SAFETY EVALUATION BY THE OFFICE OF NUCLEAR REACTOR REGULATION

RELAXATION REQUEST FROM ORDER EA-03-009 REGARDING THE

ENTERGY OPERATIONS, INC.

WATERFORD STEAM ELECTRIC STATION, UNIT 3

Figure 1

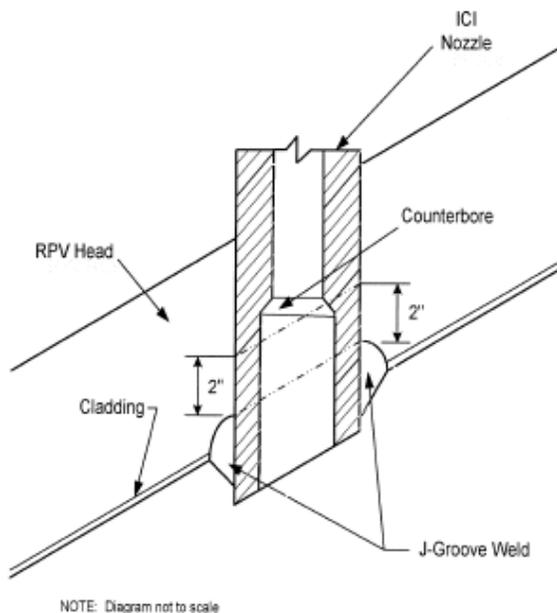
The licensee states that the ICI nozzles are manufactured with a counterbore above the J-groove weld (Figure 1). According to the licensee, because of UT transducer liftoff at the counterbore, a UT blind zone exists at the upper hillside location (180° azimuth) of each ICI nozzle and the blind zone measures approximately 0.88 inch in axial length. The licensee states that the portion of the counterbore blind zone that lies within the required inspection zone of 2 inches above the J-groove weld is centered at the upper hillside location of each nozzle, and is estimated to have a circumferential extent of approximately 135° or less. The blind zone associated with the counterbore does not exist at any other azimuthal location along the circumference of the ICI nozzle within the required 2-inch inspection area above the J-groove weld. The licensee states that the counterbore is significantly closer to the J-groove weld on the upper hillside of the nozzle than on the lower hillside, due to the RPV head angle at the ICI locations. The licensee also states that no volumetric inspection equipment is available to inspect the counterbore region, and resolving the UT limitations due to the counterbore would require eliminating the counterbore region through a physical modification of the nozzle itself.

Within the context of the licensee's proposed alternative examination of the RPV penetration nozzles, the licensee has demonstrated that hardship would result from implementing UT examinations to the counterbore region of the ICI nozzles, associated with modifying the region to allow access by the UT probe to collect data in the counterbore region. The staff finds that the nozzles' counterbore area makes inspection of these nozzles in accordance with Order EA-03-009 difficult and would involve a hardship or unusual difficulty. The licensee proposes to perform a surface examination of the nozzle ID surface 2 inches above the J-groove weld that falls within the blind zone in the counterbore region of all 10 of the ICI nozzles. This evaluation focuses on the issue of whether there is a compensating increase in the level of quality and safety such that these nozzles should be UT inspected despite this hardship.

The staff finds that the licensee's proposed alternative examination of the 10 ICI RPV head penetration nozzles which includes performing a surface examination on the area of material that is not receiving a UT examination per the requirements of Section IV.C.(1)(b)(i) of the Order, i.e., the "blind zone" in the counterbore region, is sufficient to detect the PWSCC phenomenon and therefore provides reasonable assurance of structural integrity of the RPV head, VHP nozzles, and welds. Further inspection of the ICI nozzle counterbore region in accordance with Section IV.C.(1)(b)(i) of Order EA-03-009, would result in hardship or unusual difficulty without a compensating increase in the level of quality and safety.

The staff concludes that the licensee's proposed alternative augmented surface examination of the ICI RPV head penetration nozzles in the counterbore blind zone region above the J-groove weld, provides reasonable assurance of the structural integrity of the RPV head, VHP nozzles, and welds. Further inspection of the ICI nozzle counterbore region in accordance with Section IV.C.(1)(b)(i) of Order EA-03-009 would result in hardship or unusual difficulty without a compensating increase in the level of quality and safety.

Figure 2

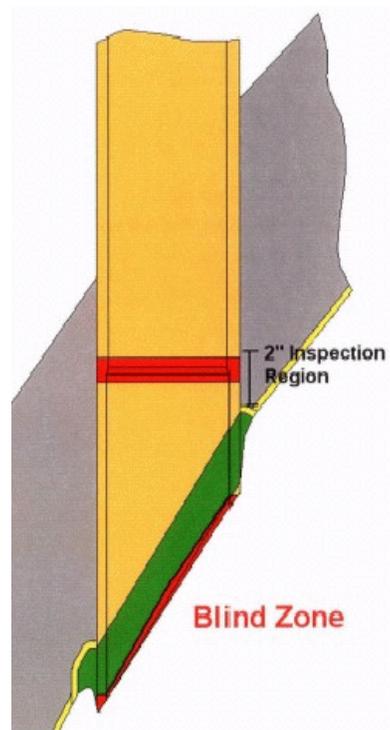
The licensee stated that it will perform a UT examination from the inside diameter (ID) of each ICI nozzle (i.e., nozzle base material) in accordance with Section IV.C(1)(b)(i) of the Order, with the exception of the blind zone at the bottom of each ICI nozzle, and the blind zone in the counterbore region above the J-groove weld of each ICI nozzle. For illustration purposes, Figure 1 shows the ICI nozzle configuration and Figure 2 shows the location of the blind zones. Figure 1 was taken from the licensee's October 24, 2003, letter, and Figure 2 was taken from the licensee's presentation that it gave at NRC headquarters on August 14, 2003.

Entergy states that a blind zone exists along the bottom of each ICI nozzle and varies from approximately 0.20 inch to 0.70 inch. According to the licensee, the blind zone at the end of the nozzle occurs due to loss of coupling as the transducers traverse across the bottom end of the nozzle. The licensee states that this problem is further compounded by the configuration of the ICI nozzle bottom end, which is cut to match the contour of the RPV head. The licensee further states that it is not aware of any equipment currently available that will resolve the configuration limitation.

The staff finds that by performing a surface examination on the area of material that is not receiving a UT examination per the requirements of Section IV.C.(1)(b)(i) of the Order, i.e., the "blind zone" at the end of nozzle, the licensee is performing an examination that is sufficient to detect the PWSCC phenomenon. The staff also notes that the augmented inspection covers the entire wetted surface of the volume of material at the bottom of the nozzle that is not

The staff also concludes that the licensee's proposed alternative examination of the ICI RPV head penetration nozzles, to perform a surface examination of the blind zone at the bottom of the ICI nozzles, provides reasonable assurance of structural integrity of the ICI nozzles and, thus, provides an acceptable level of quality and safety consistent with Criterion (1) of Section IV, Paragraph F, of Order EA-03-009.
